## **Disability Access Report**

**Project:** Mona Vale Surf Club  
**Address:** Surf View Road, Mona Vale NSW  
**Stage:** Development Application

**Ref:** J000292  
**Date:** 24 October 2018

**For:** Northern Beaches Council % Warren and Mahoney

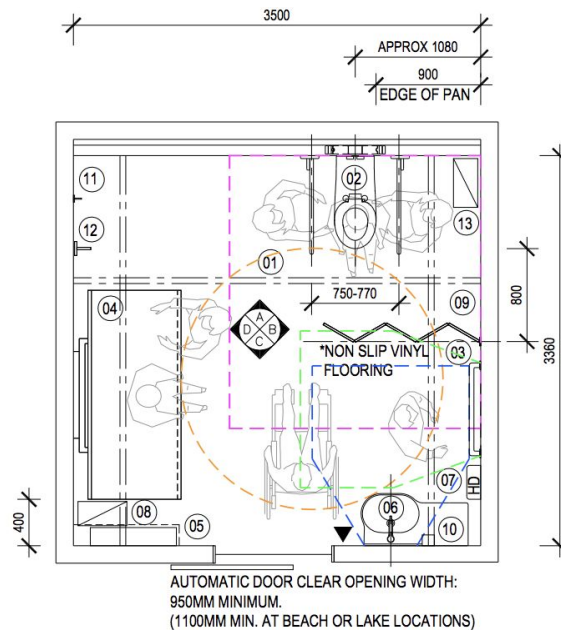
accessible features of AS1735.12 as required by Table E3.6b BCA
F2.4 Accessible sanitary facilities	✓	<p><b>Accessible Toilets</b></p> <p>An accessible toilet and shower facility is proposed on the ground level within the public amenities. The ground floor public accessible toilet and change room will not meet the deemed-to-satisfy provision of the BCA to provide an accessible toilet/shower in accordance with AS1428.1 (2009).</p> <p>There is a lifting hoist shown on the drawings and the toilet pan is located more than 450mm from the side wall.</p>  <p>From Ground plan DDA change room by Warren and Mahoney</p> <p>By CC need to confirm whether this is to meet the requirements of the 'changing places' Information Guide and Technical standard (June 2017)</p> <p><a href="https://changingplaces.org.au/">https://changingplaces.org.au/</a></p>

1. The proposed Ground Floor change room and toilet requires a performance solution by Construction Certificate stage.
2. For the level 1 accessible toilet, to comply with BCA ensure fixtures and fittings for the accessible toilet and shower is in accordance with AS1428.1. (2009).
